NEW MEXICO ENVIRONMENT DEPARTMENT

Re: Chevron Mining, Inc. (CMI), Questa Mine; MSGP; SIC 1061; NPDES Compliance Evaluation Inspection (CEI); NMR053300; July 24 thru July 26, 2018

NPDES Compliance Inspection Report

NMED/SWQB
Official Photograph Log
Photo # 1

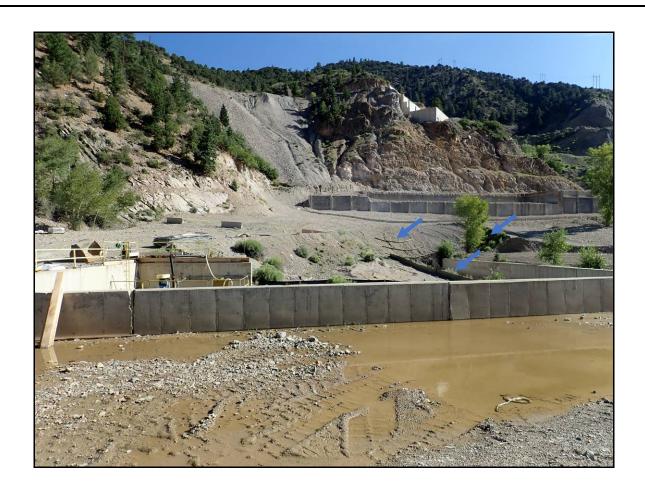
<u>Unit 1</u>: Runoff that enters or occurs in the West Gate Laydown area in Unit 1 is not directed toward Outfall 005 covered by the NPDES Individual Permit NM0022306 as described in SWPPP or as shown on SWPPP Mine Site Map. The West Gate Laydown area in Unit 1 was not covered on the day if this inspection by another NPDES permit based on discussions with Permittee Representatives. Collected water existed in a remaining Mill Area concrete structure in the West Gate Laydown area. Wet soils and erosion rills indicated some flow in the West Gate Laydown area would be toward the southern mine property boundary along NM 38 and entrance. Water had ponded in a low area near the entrance to NM 38. No evidence of discharge was observed from the West Gate Laydown Area in Unit 1. SWPPP Mine Site Map was not updated to include flow directions, berms, ditches, wattle, and silt fence controls. Inspection of the West Gate Laydown area is not documented on Routine Facility Inspection reports. Photos #1 thru #4 for the West Gate Laydown area are attached.

Subject: Looking north in southwest portion of Unit 1 at erosion rills and gullies on slopes; remaining mill structures, including concrete structure that collects water. Arrows point to ditch, straw wattles and silt fence controls.

The West Gate Laydown area is currently being used to support the Lower Sulphur Gulch Project under CERCLA and was included in the approved work plan for the project. Under CERCLA, an individual construction permit is not required; however, inspections and mitigations related to stormwater are still required. The location documented in the inspection has been mitigated as of 9/18/18.

NMED/SWQB
Official Photograph Log
Photo # 3

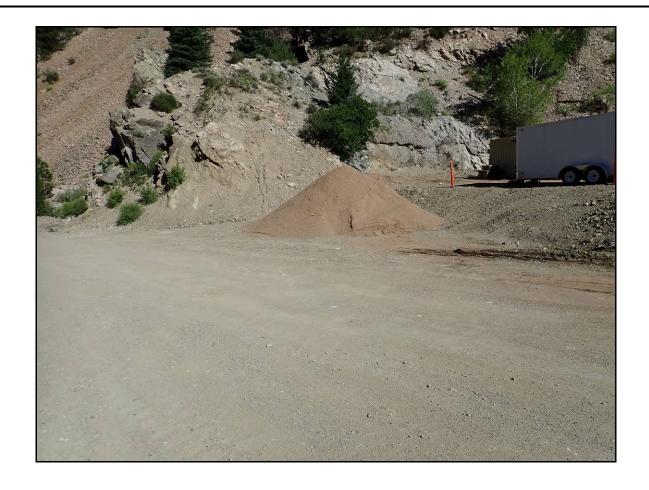
Subject: Material storage pile with fine-grained solids near entrance driveway to West Gate Laydown Area. No containment or sediment controls observed for pile.

NMED/SWQB
Official Photograph Log
Photo # 6

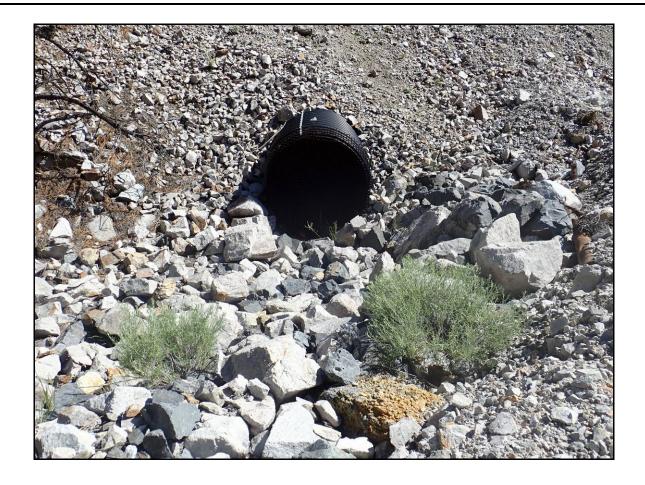
Potential Additional Outfall: CMI's NOI and SWPPP describes two outfalls for the runoff from the Eastern Diversion Ditch and tailing facility area (Outfall SWED at Latitude 36.6973°, Longitude -105.6202°) in Unit 14 and runoff from Capulin Rock Pile and Canyon to stormwater catchments (Outfall SWLC at Latitude 36.6987°, Longitude -105.5492°) in Unit 10. A culvert structure in Unit 4, approximately Latitude 36.694987°, Longitude -105.497526°, exists at the base of the Sulphur Gulch South Rock Pile which has the potential to convey stormwater discharge off the property boundary to roadway ditches and roadway culvert crossings to Red River. The structure is not discussed in SWPPP (e.g., purpose of structure, flow direction, elevations, estimated water levels needed for discharge, etc.). Photos #5 and #6 of the potential outfall structure are attached.

Subject: Culvert outlet structure in roadside rockpile highway and entrance berm. Rock armors the shallow channel directly below the outfall. The shallow channel continues toward the highway and appears partially interrupted by a low berms from the highway. No evidence of discharge was observed during this inspection. This outlet structure and the shallow channel is not shown on the SWPPP Mine Site Map and is not identified as a potential outfall in the SWPPP or NOI.
